**W. M. JORDAN COMPANY'S ADDENDUM NO. 2**

***PROJECT: THE WILMINGTON FOOD BANK CD SET***

***DATE: 12/7/21***

4. Revised civil drawings C-2.0, C-4.0, C-6.4, L-2.0. Included in this Addendum. See plan room.
5. Question: Will Penco be an acceptable manufacturer for the lockers?

L-2.0

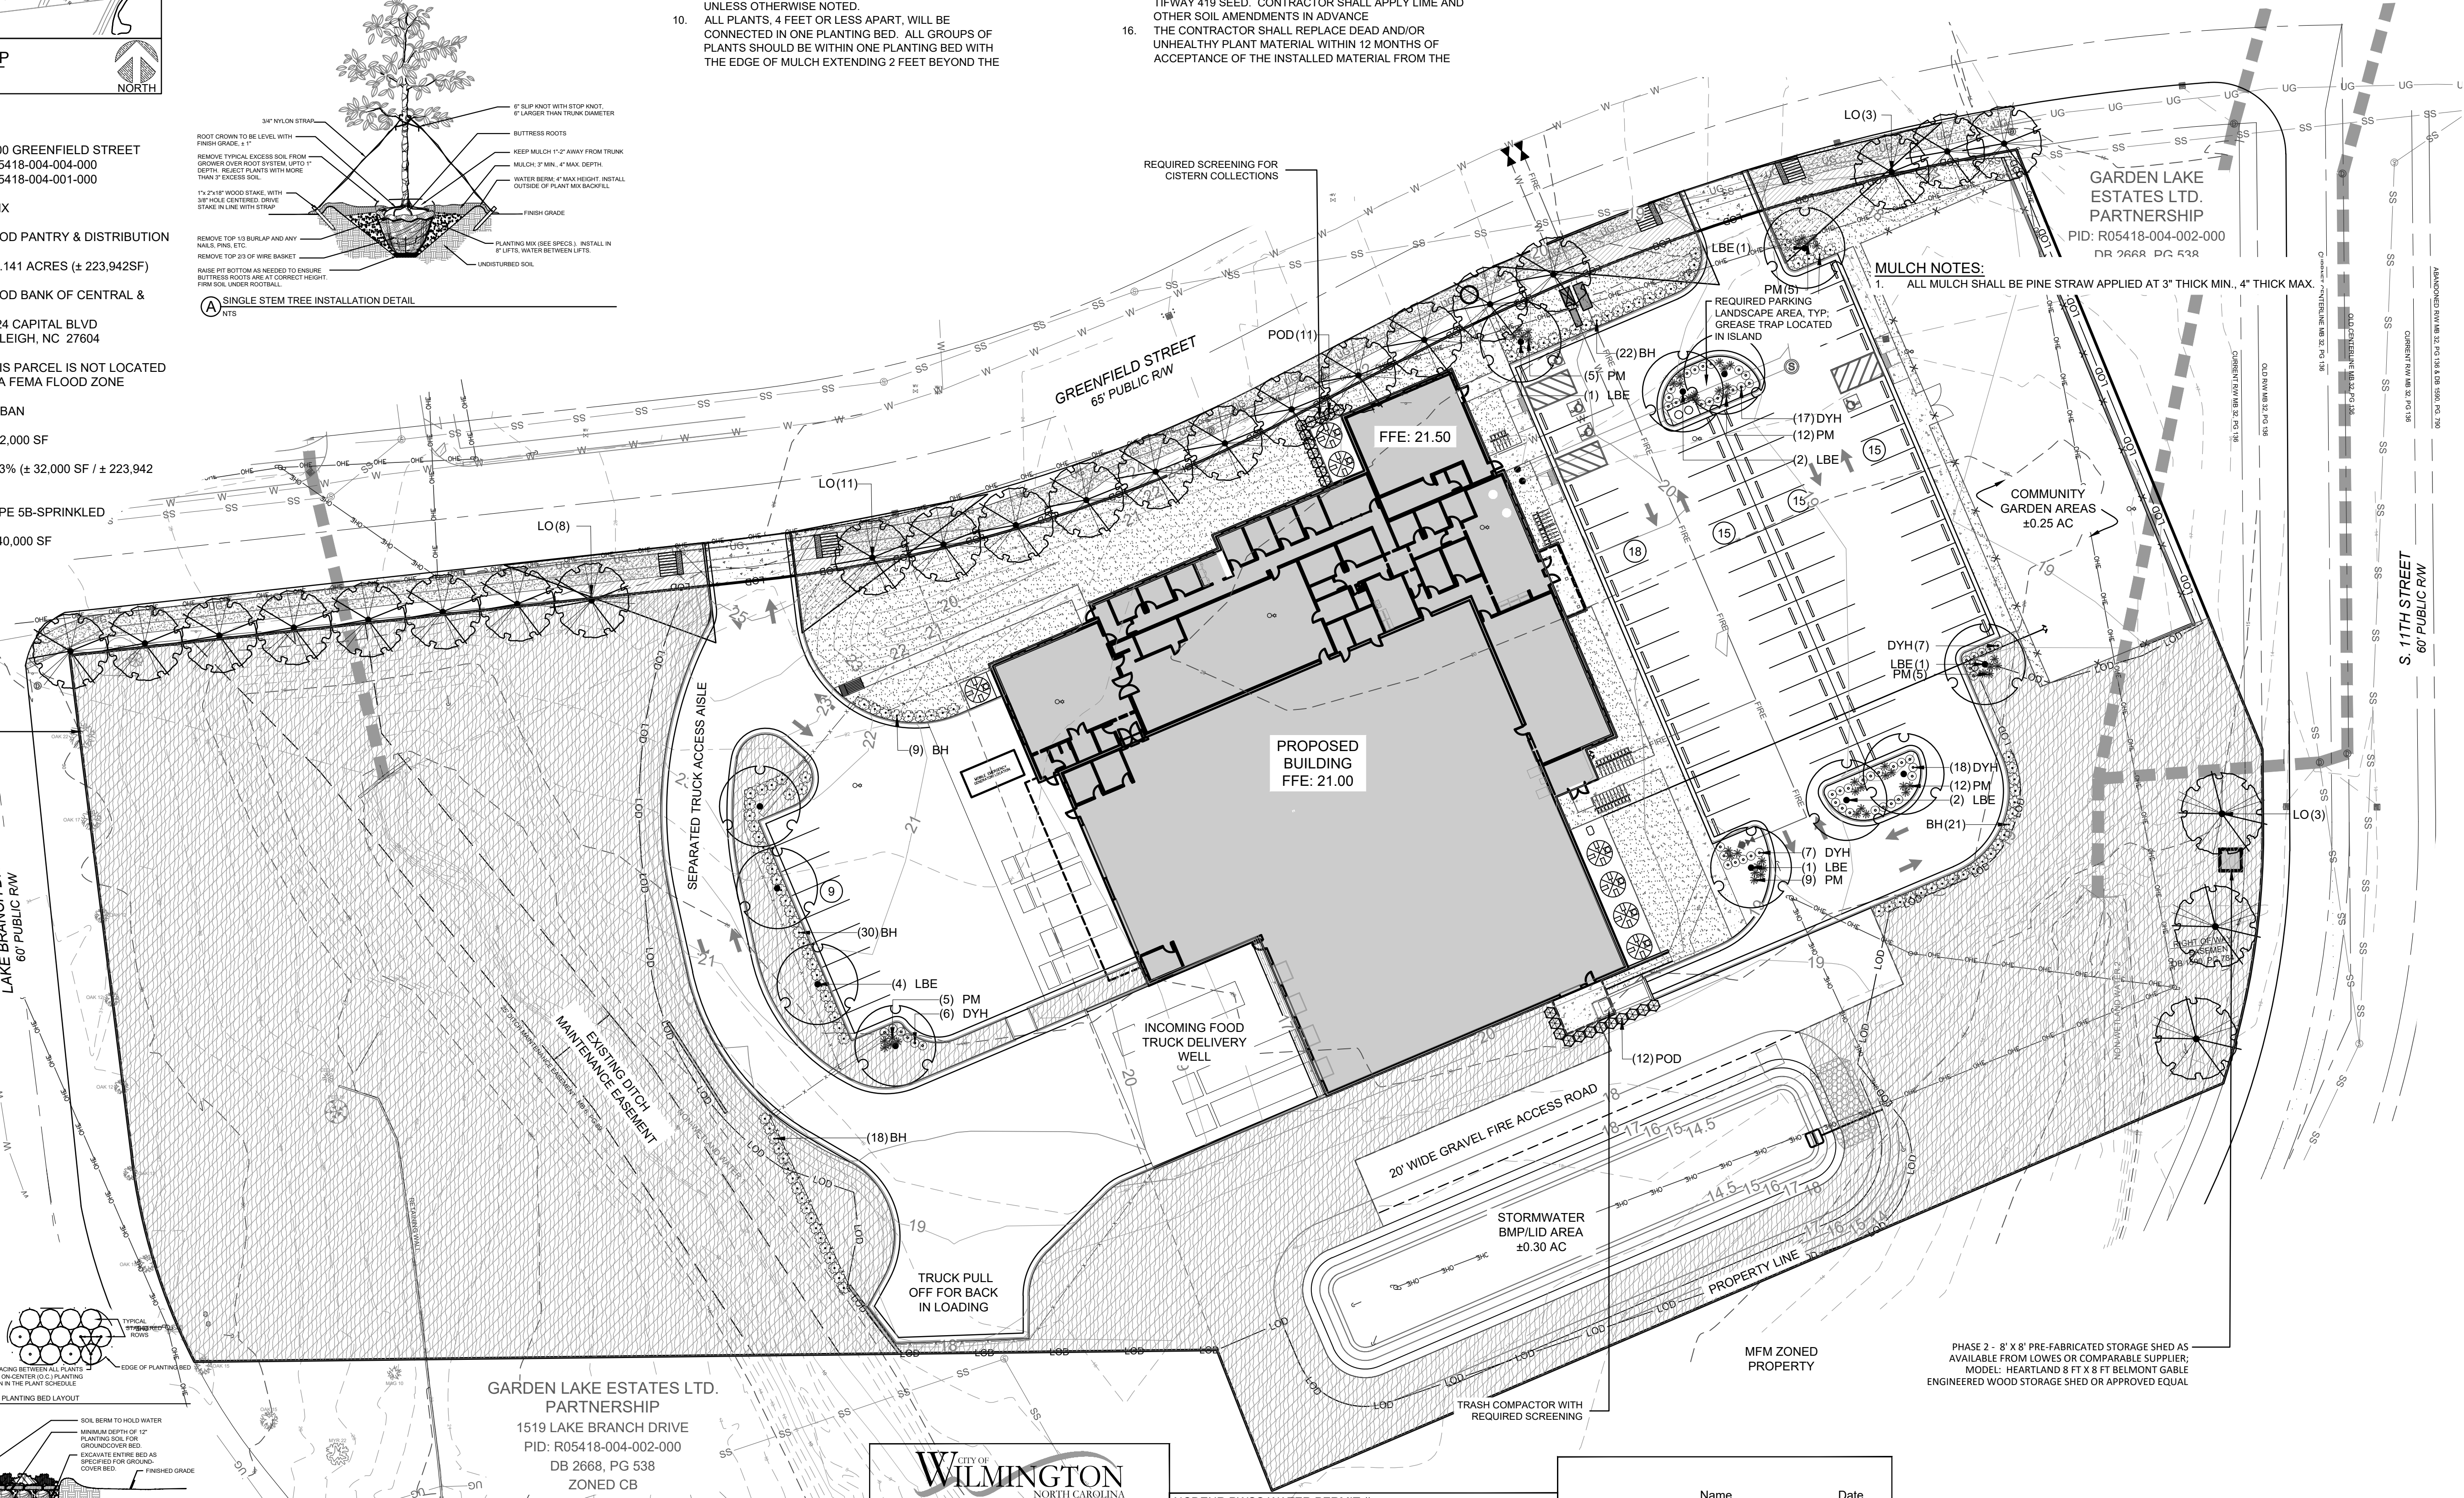
9. Question: Is the cistern system that is being provided/installed by others going to irrigate the landscaping/seed/SOD also or just the garden?  
**Answer: Landscape notes have been updated on L-2.0 to indicate that sod/seed areas not to be included in the cistern areas; Cisterns to irrigate community gardens; BP-32A Landscaping contractor is responsible for design and installation of irrigation for seed/sod areas. Including backflow needed for system.**
